CBE, Sierra Club, Center, ForestEthics et al. Comments on the Revised Draft Environmental Impact Report for the Phillips 66 Company Rail Spur Extension and Crude Unloading Project

Expert Report of Greg Karras on the Revised Draft Environmental Impact Report for the Phillips 66 Rail Spur Extension and Crude Unloading Project, November 2014.

**Phillips 66 Company Rail Spur Extension and Crude Unloading Project
Revised Draft Environmental Impact Report (RDEIR)** dated October 2014
Prepared for San Luis Obispo County
State Clearinghouse #2013071028
County File #DRC2012-00095

Figure 1. Total Central Coast OCS, offshore, and onshore oil production of fields supplying crude oil to the Phillips 66 SMF from 1995–2012, and forecast to 2050.

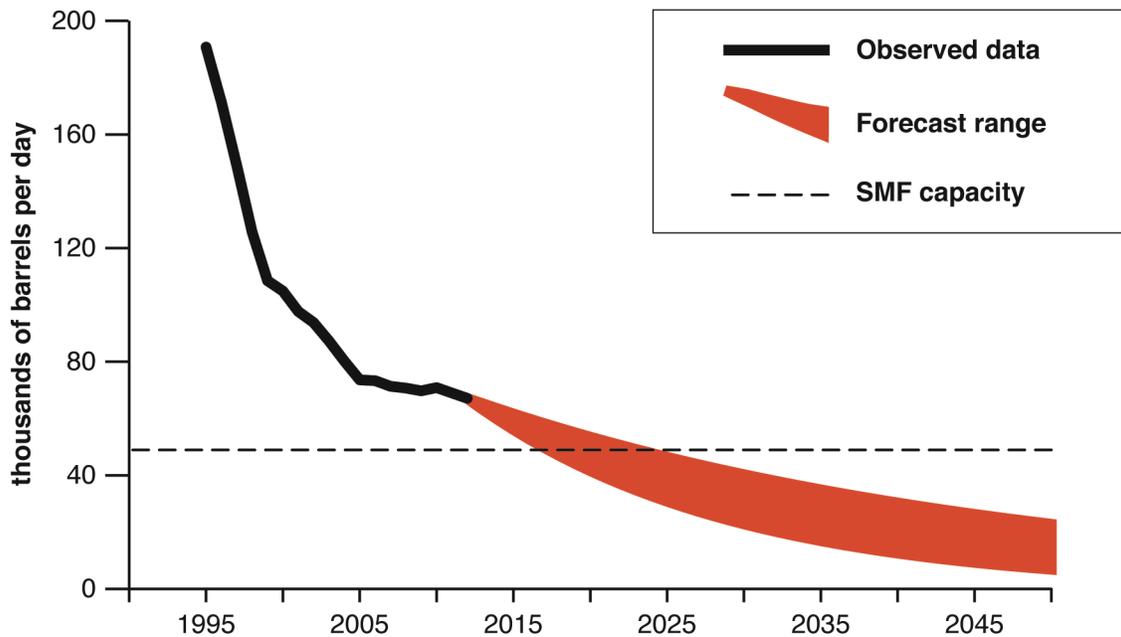
13. Abundant evidence that the RDEIR does not include or analyze demonstrates that declining local and regional crude production could greatly affect SMF operation.⁷ Total California crude production supplied to refineries statewide has declined by 43% from its peak of 1.10 million barrels per day in 1986 to 631 thousand barrels/day (Mb/d) in 2013, and California crude now supplies only 40% of statewide refinery crude input.⁸ Statewide, coastal onshore production was 137 Mb/d in 1977 but only 60.3 Mb/d in 2012, indicating a gross decline of -56% and a year-on-year decline averaging -2.0%/year in this period.⁹ State offshore production peaked in 1978 at 107 Mb/d and was 35.6 Mb/d in 2012, indicating a gross decline of -67% and a year-on-year decline averaging -3.6%/y.¹⁰ In California's San Joaquin Basin, crude production peaked in 1986 at 745 Mb/d and was 405 Mb/d in 2012, a gross decline of -46% and annual decline averaging -2.3%/y.¹¹ California federal Outer Continental Shelf (OCS) production peaked in 1995 at 197 Mb/d and was 41.1 Mb/d in 2012, a gross decline of -79% and an average year-on-year decline during this period of -8.3%/y.¹² Some 13 Central Coast OCS, state offshore and onshore fields have been identified as sources of crude for the SMF.¹³ Total production from these 'local supply' sources was 191 Mb/d in 1995 but only 67.1 Mb/d in 2012, a gross decline of -65% and a year-on-year decline ranging from -2.8%/y since 2003 to -5.8%/y since 1995.¹⁴ See Figure 1. This 2.8-5.8%/year decline is within the range found elsewhere in the state that is discussed above (2.0-8.3%/y). As Figure 1 illustrates, this

2.8–5.8%/year rate of decline could result in total production from these ‘local supply’ sources falling below the maximum capacity of the SMF to process crude within a few years, and then falling further, to a small fraction of SMF design capacity, within the expected operating life of the proposed rail spur. When its crude rate falls too far below the design specifications of its existing equipment, such as its pipelines and vacuum unit, the existing SMF cannot operate efficiently or profitably.

Figure 3-6 Revised
 Proposed Refinery Fuel Gas System Block Flow Diagram

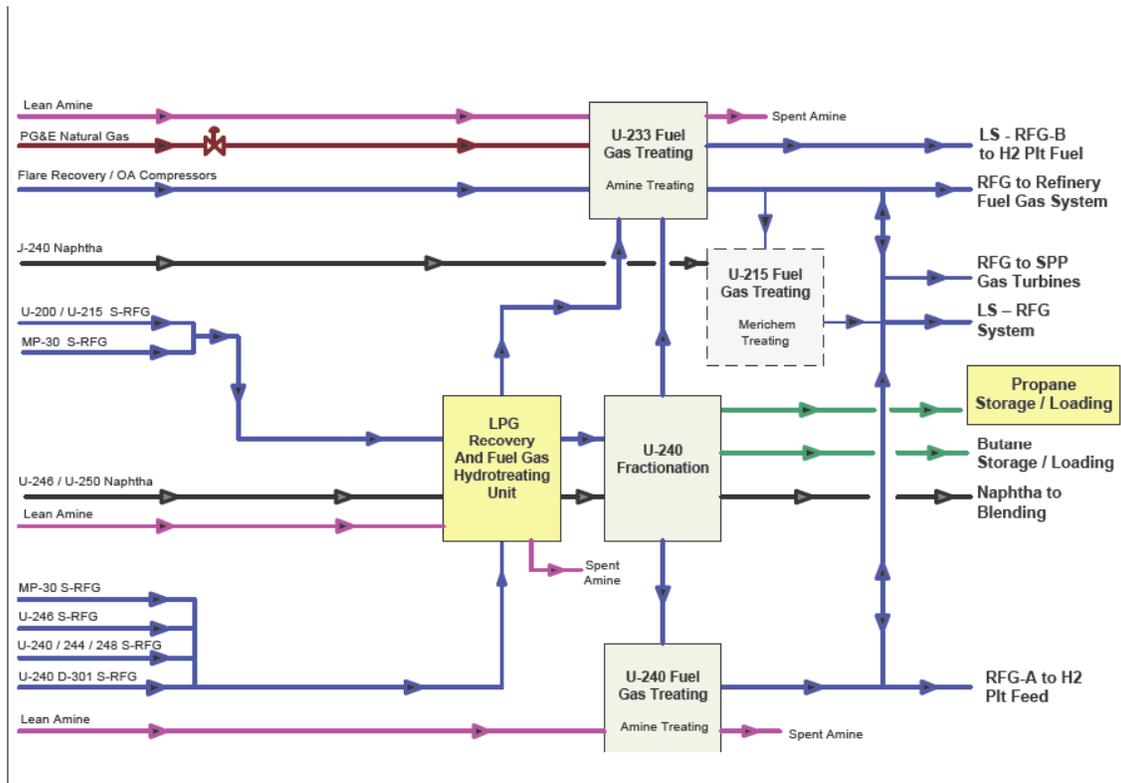
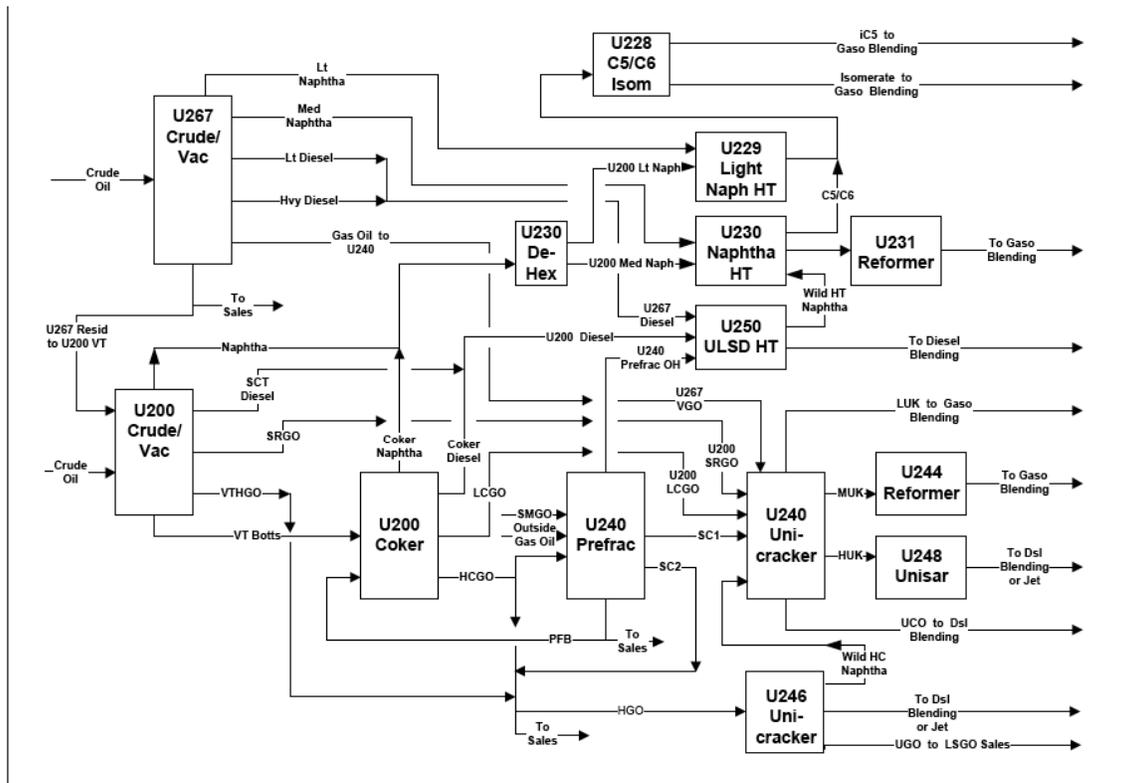
26. Importantly, an otherwise unexplained change in the project description for LPG recovery is informed by the ‘SMF project’ results for naphtha in Table 1. Naphtha from the Rodeo heavy gas oil hydrocracking unit (Unit 246) and from the HLSD Diesel Hydrotreating Unit (U250) is routed through the proposed new ‘fuel gas’ hydrotreater in Revised Figure 3-6 of the Propane Recovery RDEIR. These streams were routed through the proposed LPG recovery but *not* the proposed new hydrotreater in Figure 3-6 of the

Propane Recovery DEIR. Further, these U246 and U250 streams are ‘wild naphtha’ derived at least in part from processing the SMF gas oil (‘SMGO;’ see Figure 3-4.³⁵) Finally, these wild naphtha streams are now fed through other processes to reforming units U231 and U244 (see Figure 3-4), but revised Figure 3-6 shows the project re-routing them to naphtha blending instead. In sum, these naphtha streams are fed to the Rodeo reformers now but the revised LPG recovery proposal would instead route them through the new hydrotreater. For convenient review, Revised Figure 3-6, Figure 3-4 (both from the Propane Recovery RDEIR), and original Figure 3-6 from the June 2013 Propane Recovery DEIR are excerpted below.
